E8361A-02C

S E R V I C E N O T E

Supersedes:
E8361A-02B

E8361A PNA Series RF Network Analyzers

Figure 1

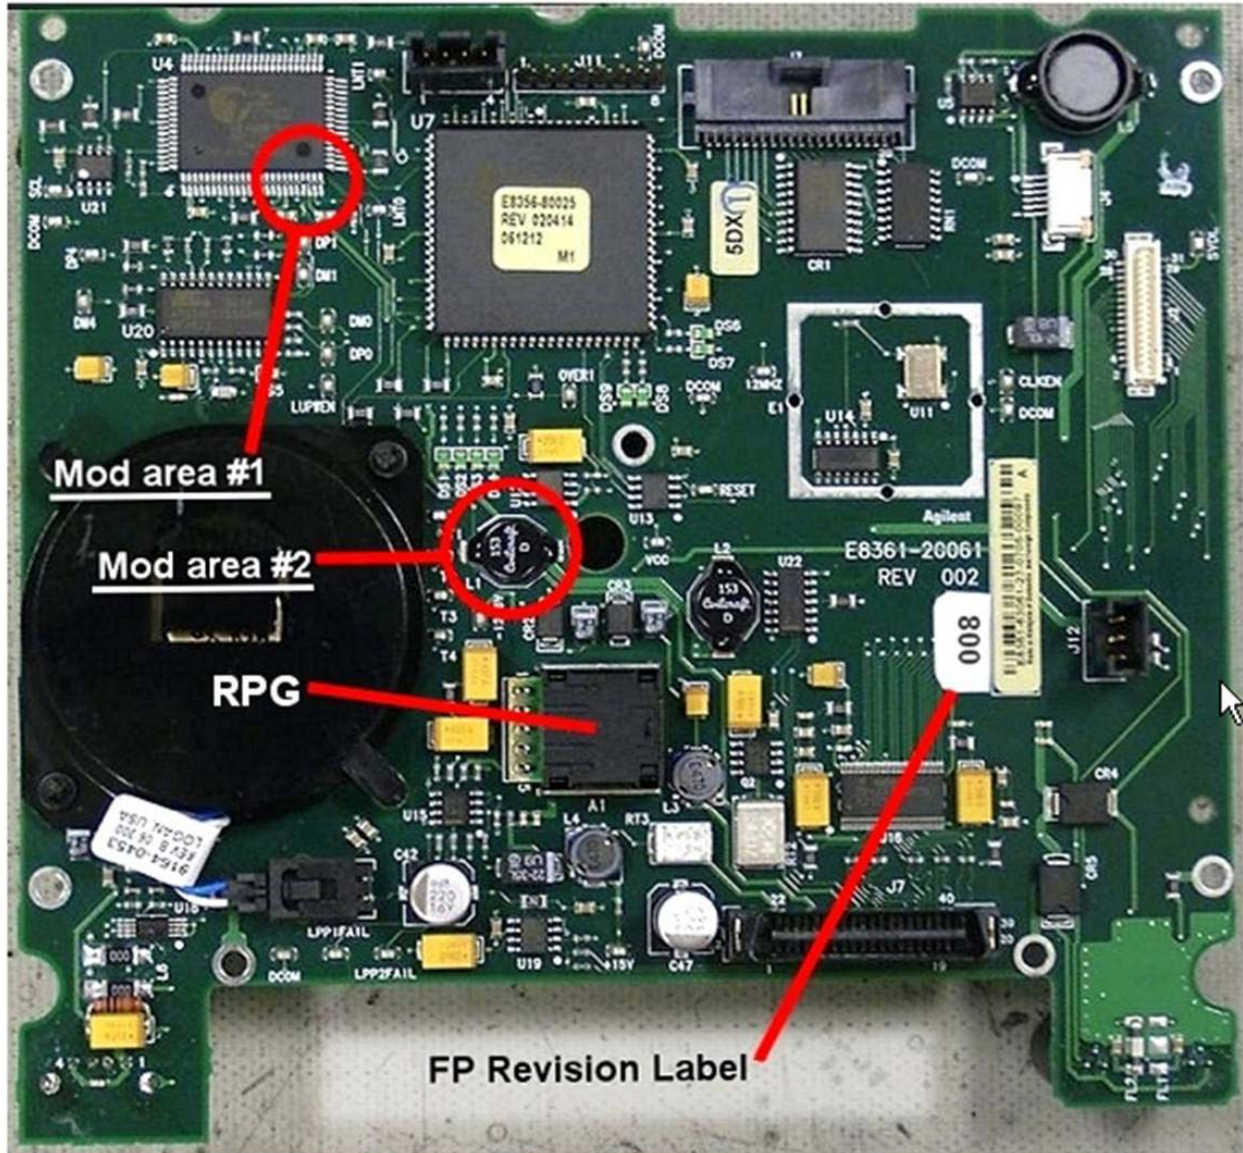
Refer to Figure 1 for the two modification areas to be addressed. Note that while this picture happens to show the FPI board completely removed from the front frame assembly, this is not necessary to perform the required modifications.

- Modification #1 consists of shorting two pins of U4 together with a small amount of solder.
- Modification #2 consist of removing L1.

Figure 2

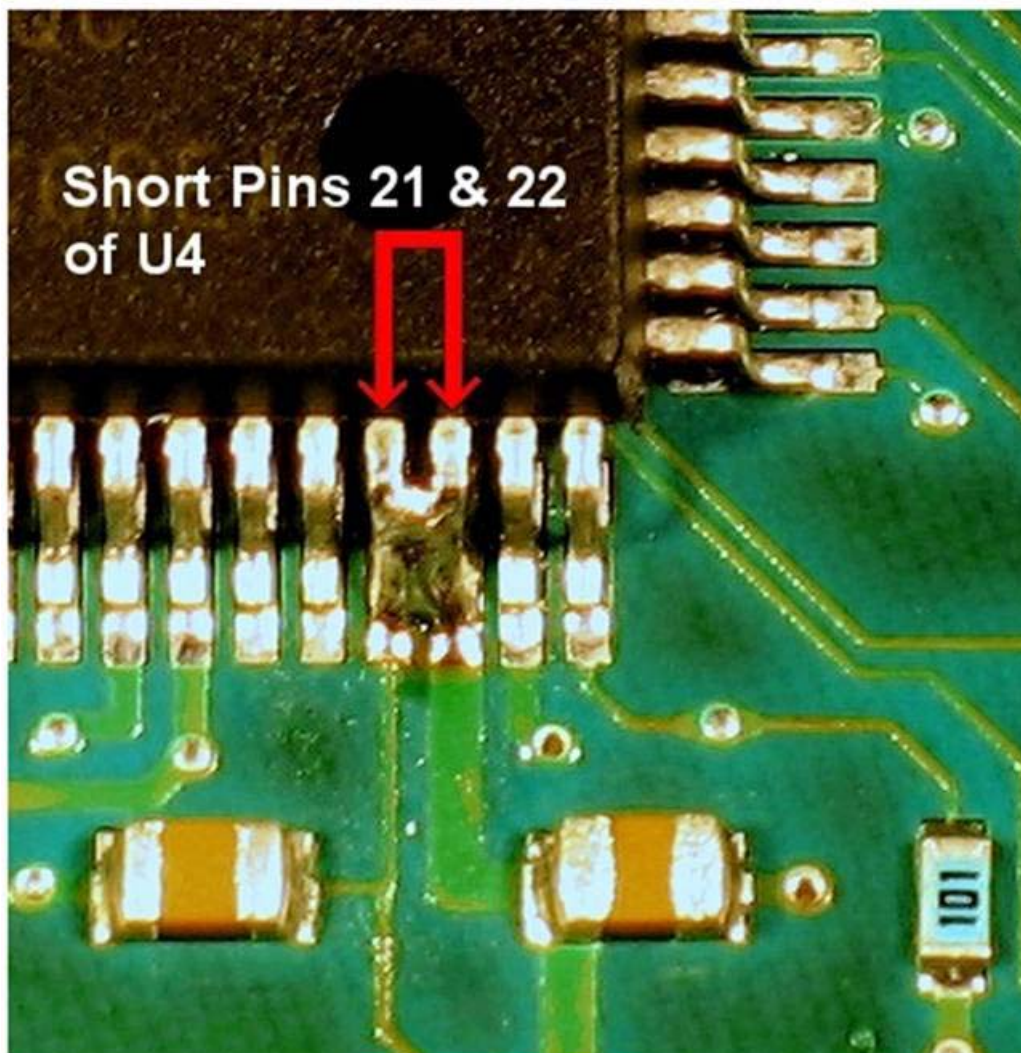
Modification #1

Carefully solder pins 21 and 22 together on U4. Refer to Figure 2 for the exact location. Use care so that no other pins are shorted. Use of a very fine tip soldering iron is recommended and a large work-task magnifying glass is very helpful.

Modification #2

Unsolder and completely remove the black surface mount inductor L1 from the front panel assembly board. This is no longer needed and can be discarded.
